1701 DEXTER AVENUE

RECOMMENDATION MEETING

AUGUST 6, 2008

LIVE/WORK LEVEL / FIRST FLOOR PLAN

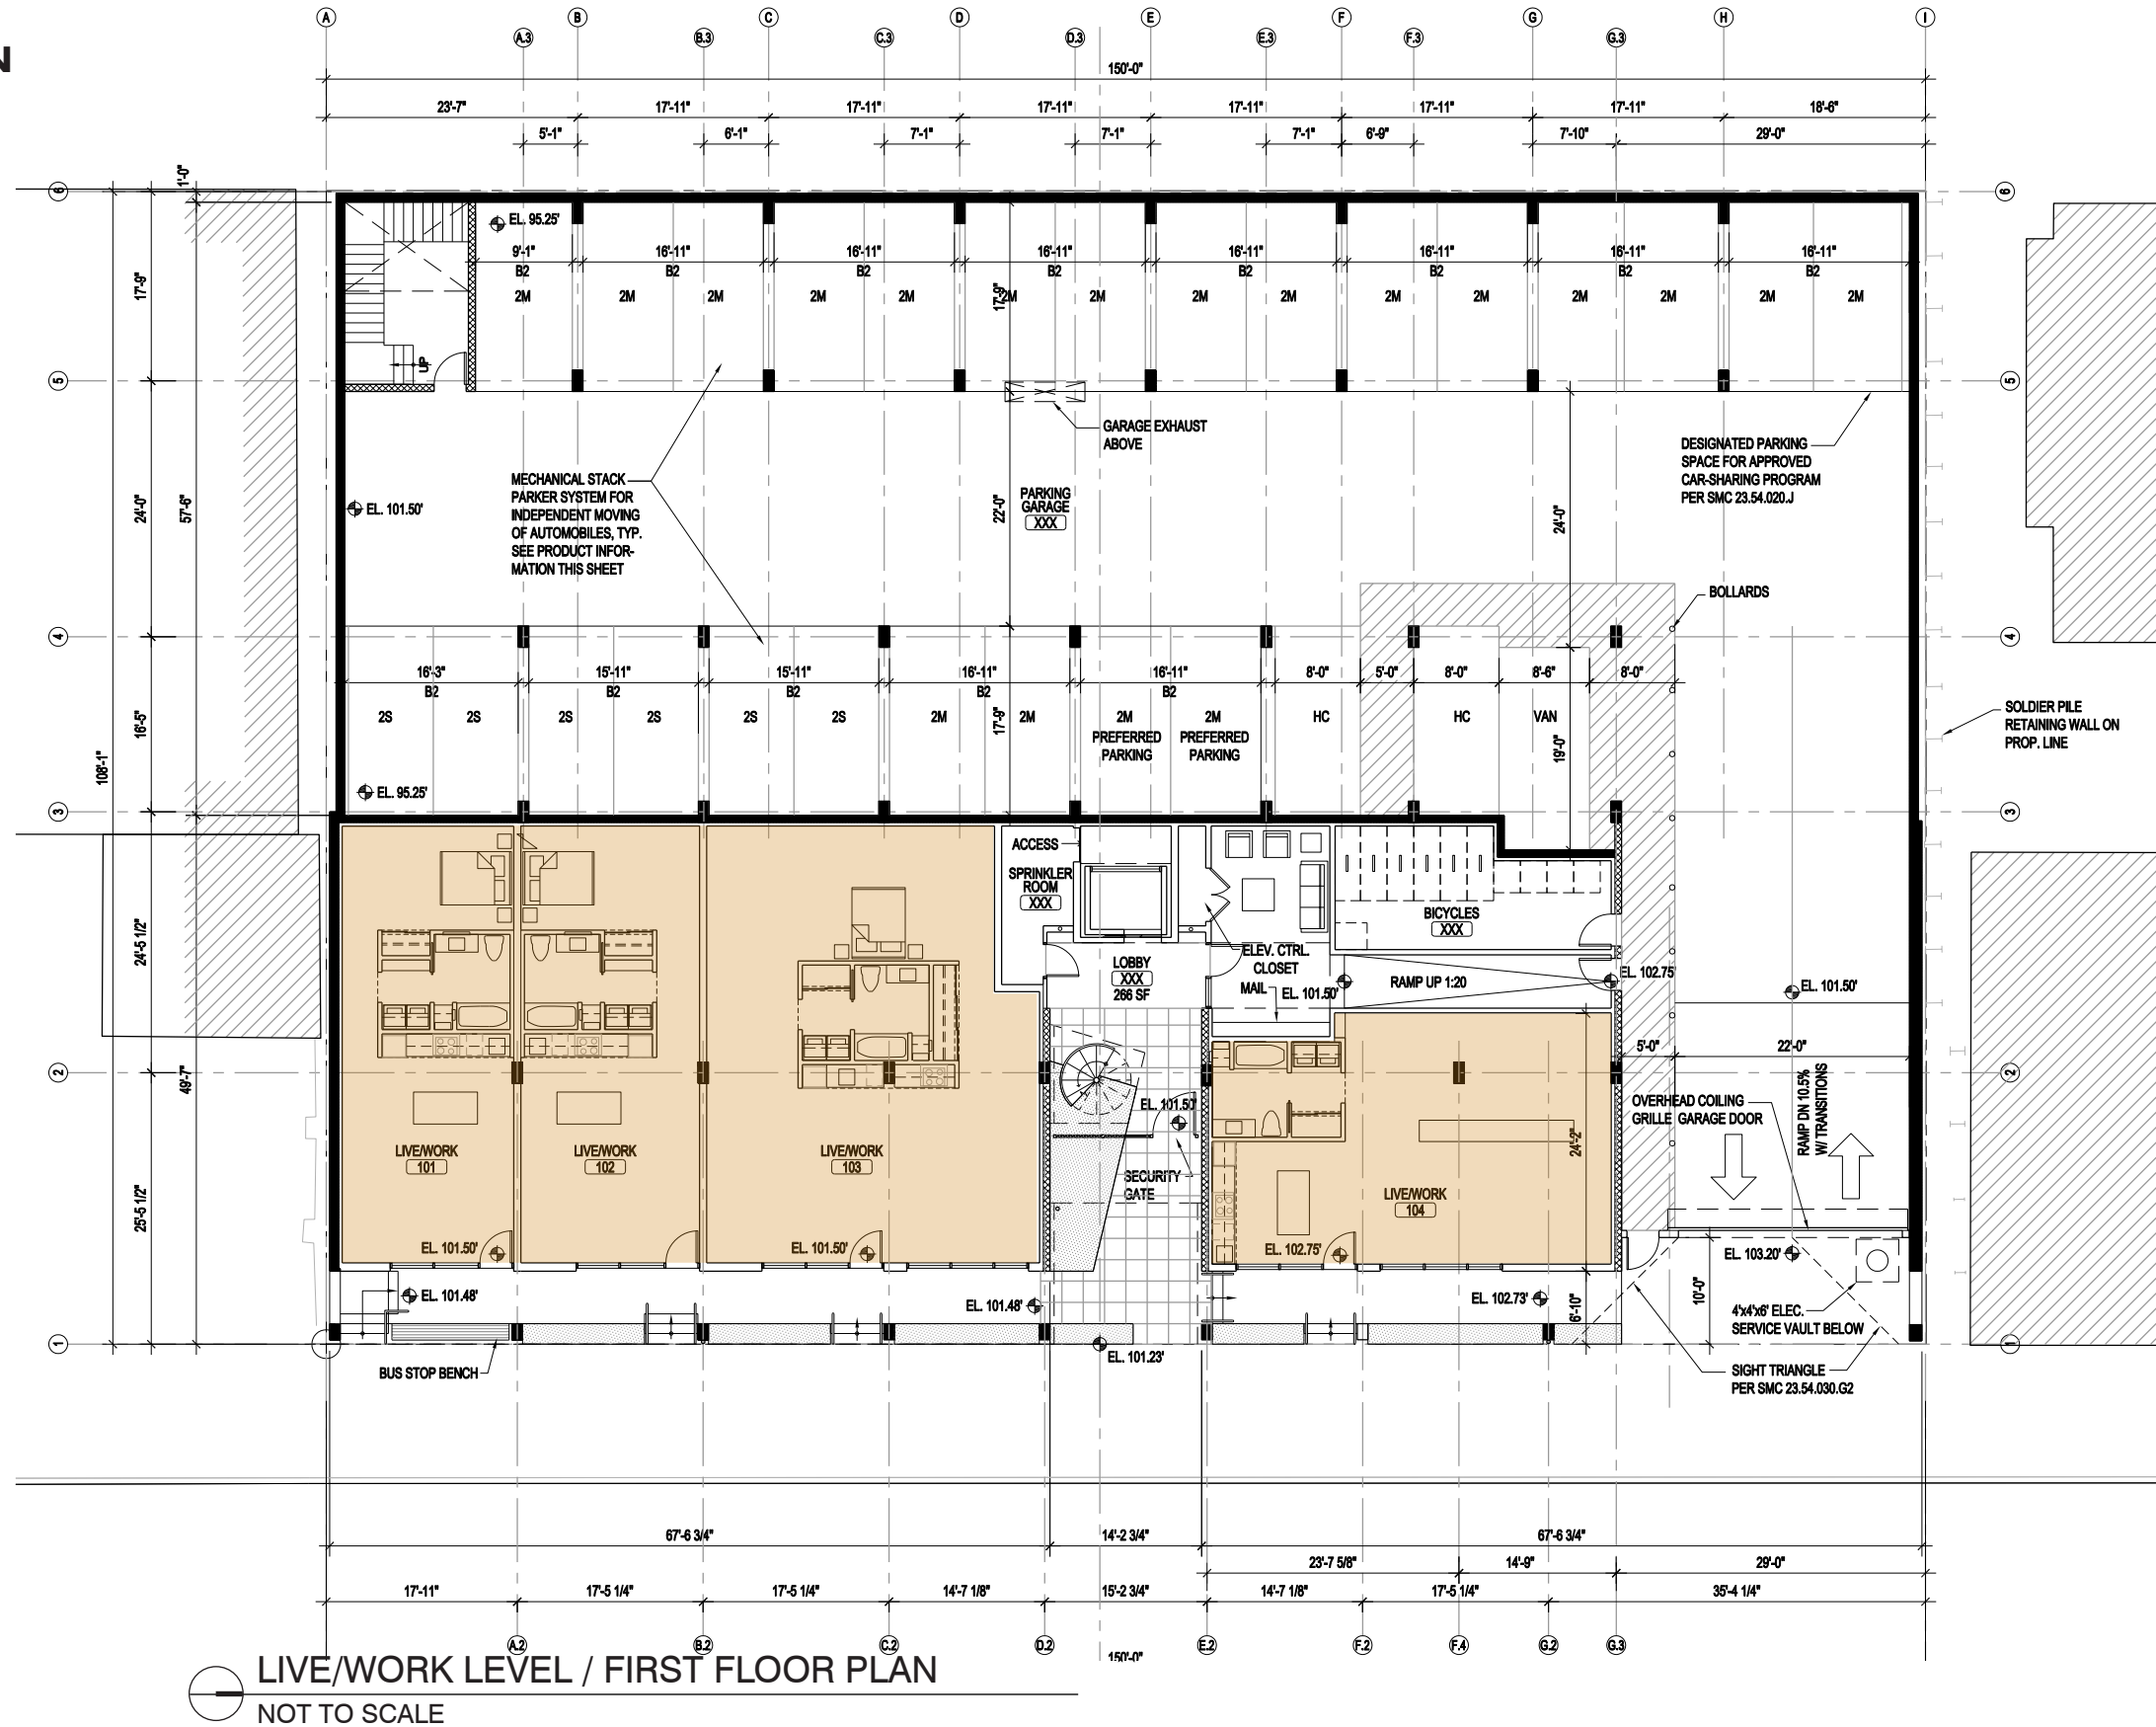
The live / work units need to be of sufficient size and any diminution of the size of these units through a request for design departures would not be regarded favorably. This caution was equally applicable to both the height and the depth of the provided units. In general the design should emphasize the 'work' rather than the 'live' nature of these street-front units.

- The zoning code depth requirement for the live/work units is 30' average depth with a 15' minimum. We are providing an average depth of 33'-8" with a 20'-10" minimum.
- The zoning code height requirement for the live/work units is 13' floor to floor. We are providing 14'-6" minimum floor to floor height.

ALLEY LEVEL / THIRD FLOOR PLAN

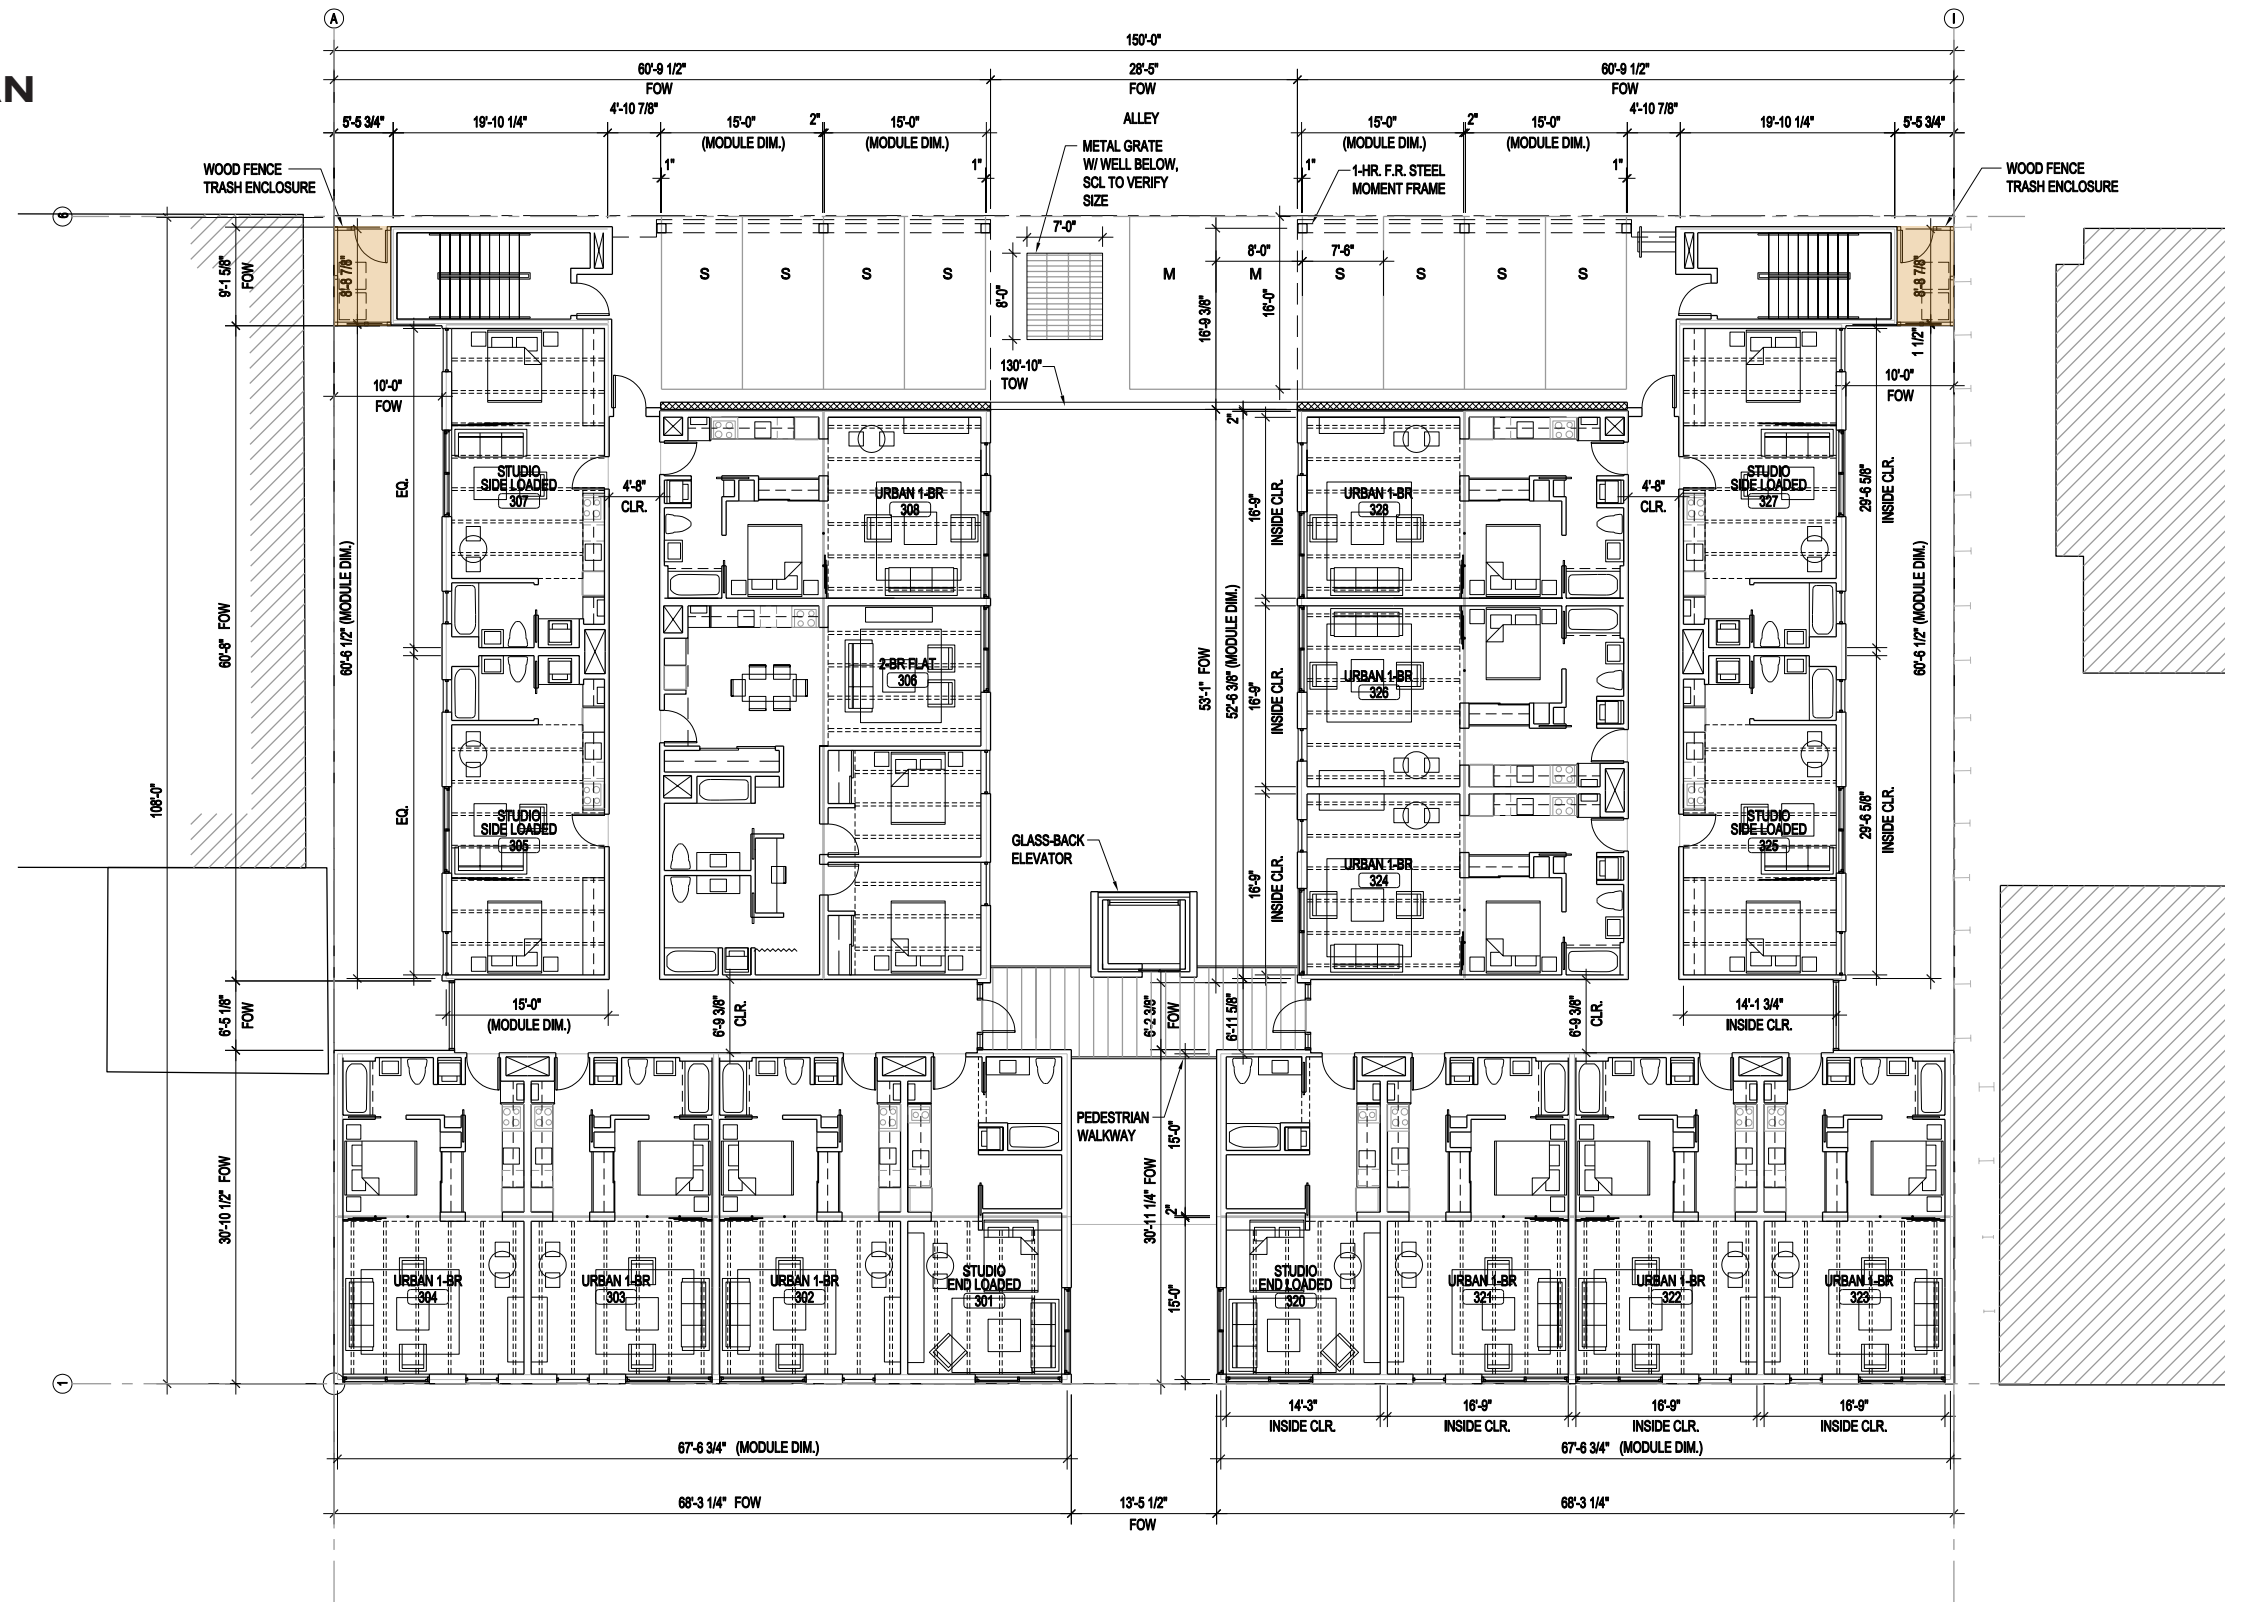
An issue related to the garage access was that of dealing with trash, garbage, and recycling materials; servicing the pick-up of these byproducts of residential living would appear to work better from the alley than from Dexter Ave N.

- We created two smaller fenced-in garbage enclosures that are accessed from the alley.
- These enclosures are sized for dumpster free service with daily garbage and recyclable collection by Cleanscapes. Cleanscapes will begin servicing this area in April 2009.
- We are confident that this is a more effective and sanitary solution than a traditional dumpster enclosure.

INTEGRATED BUS STOP

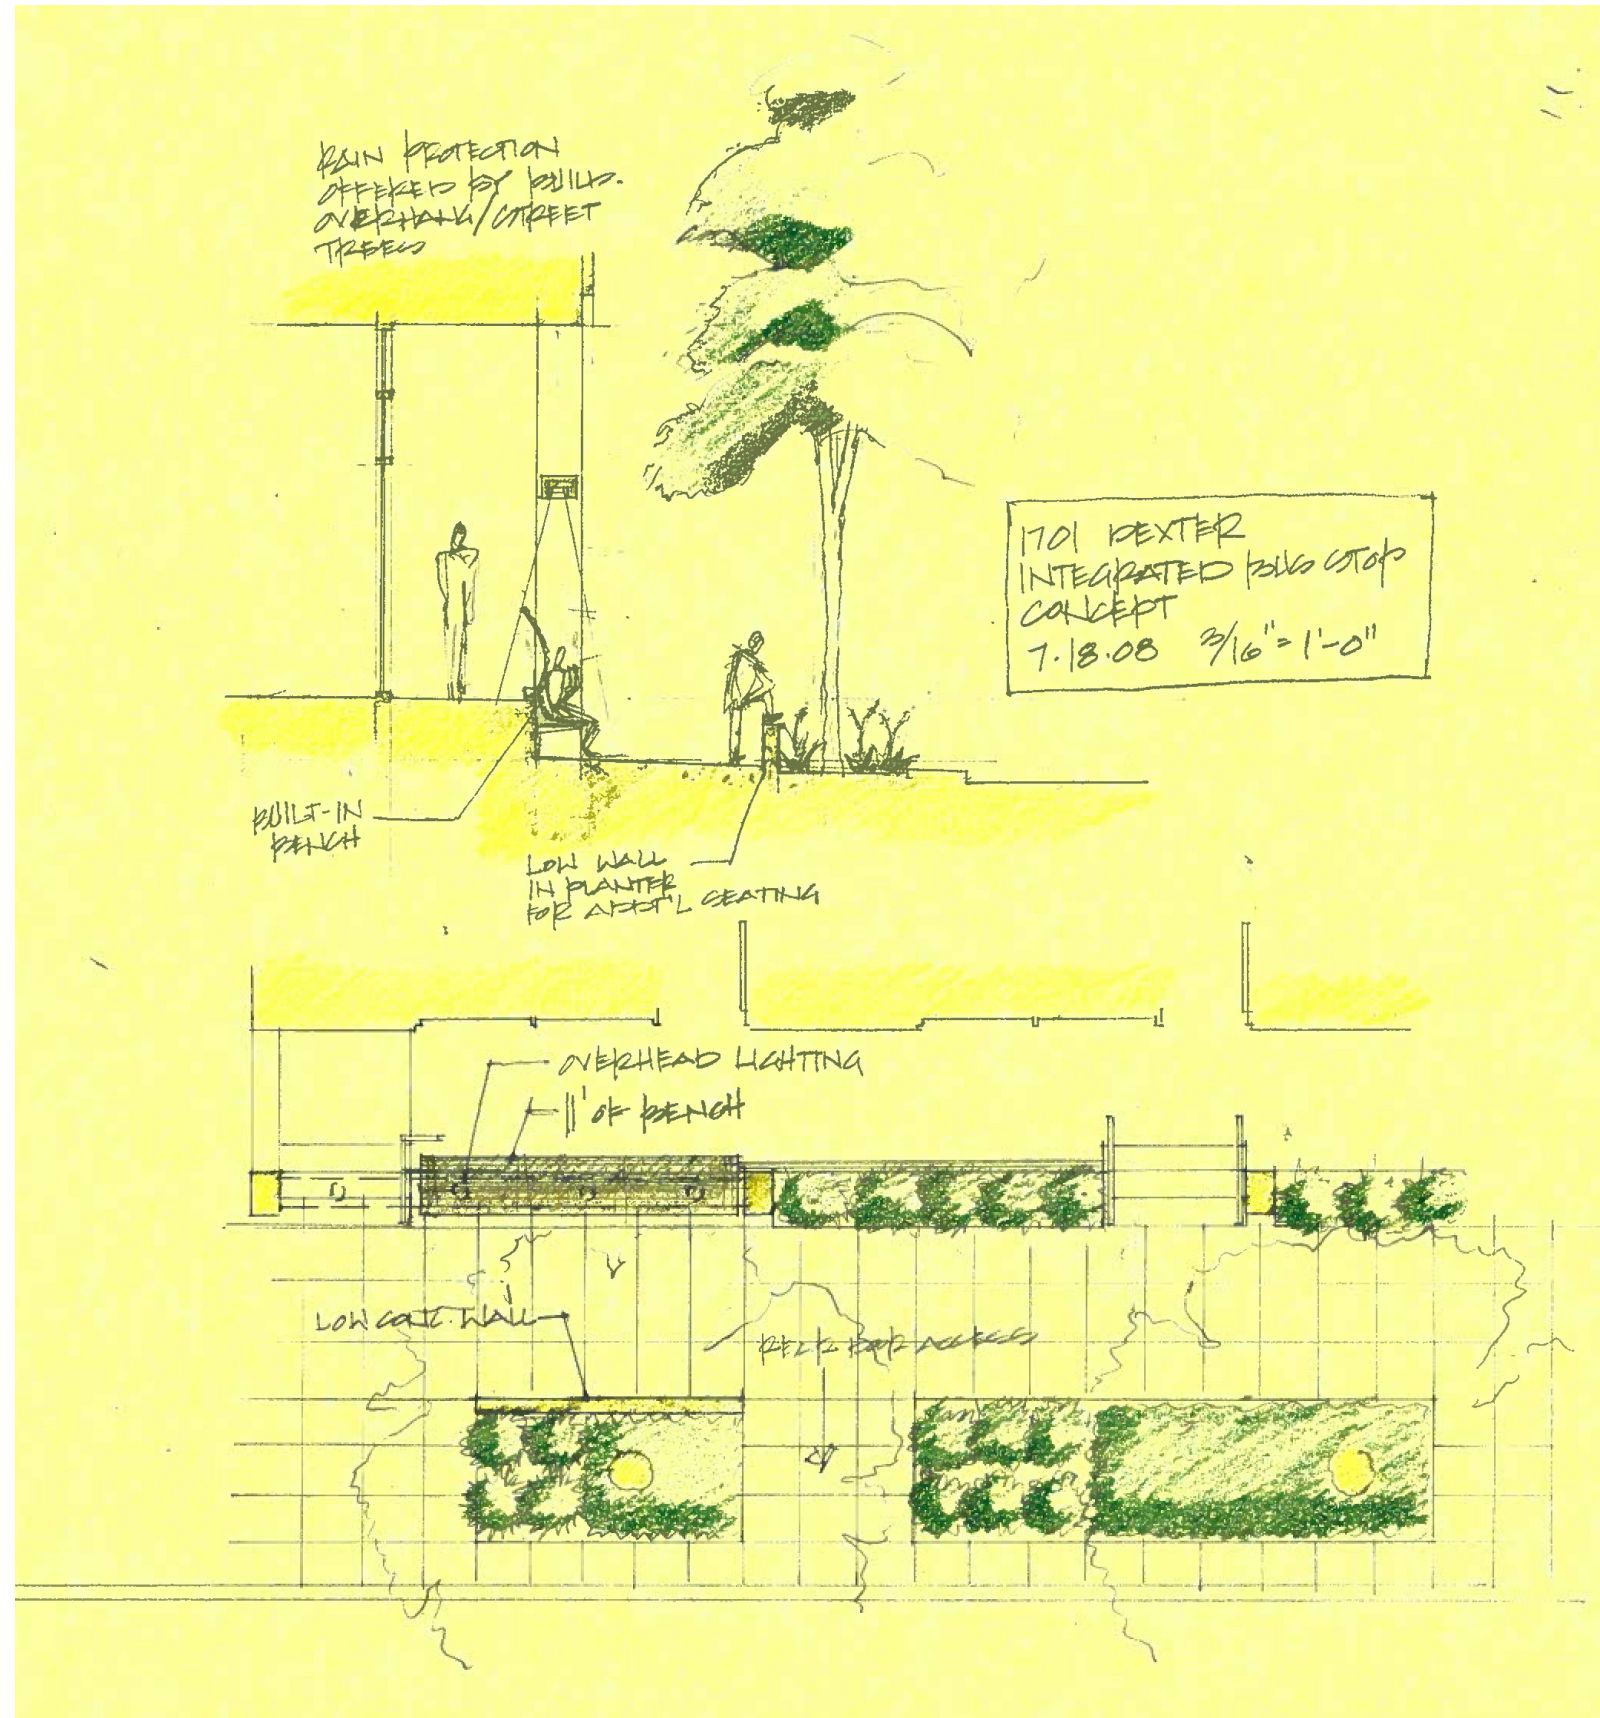
Since much had been made of promoting alternative modes of transportation for the residents within these units, the design development of the Dexter Avenue N. facade and adjoining streetscape should look for ways to incorporate the bus stop into the architecture.

- The south corner of the Dexter facade incorporates a custom, built in bench with 11 linear feet of waiting room and overhead energy efficient lighting for comfort and safety.
- The back of the bench is high enough to act as a privacy screen between the sidewalk and the most southerly live/work unit and also discourages Metro riders from leaving debris on the porch of this unit.
- The custom wood bench is designed for comfort, but will incorporate dividers to discourage loitering.
- We also propose a short concrete wall in the most southerly street planter. This wall could be used for sitting or leaning and it faces the bench for easy conversation.
- Weather protection for both elements is offered by the building overhang and the street trees.
- Metro officials have reviewed this proposed design and responded positively.
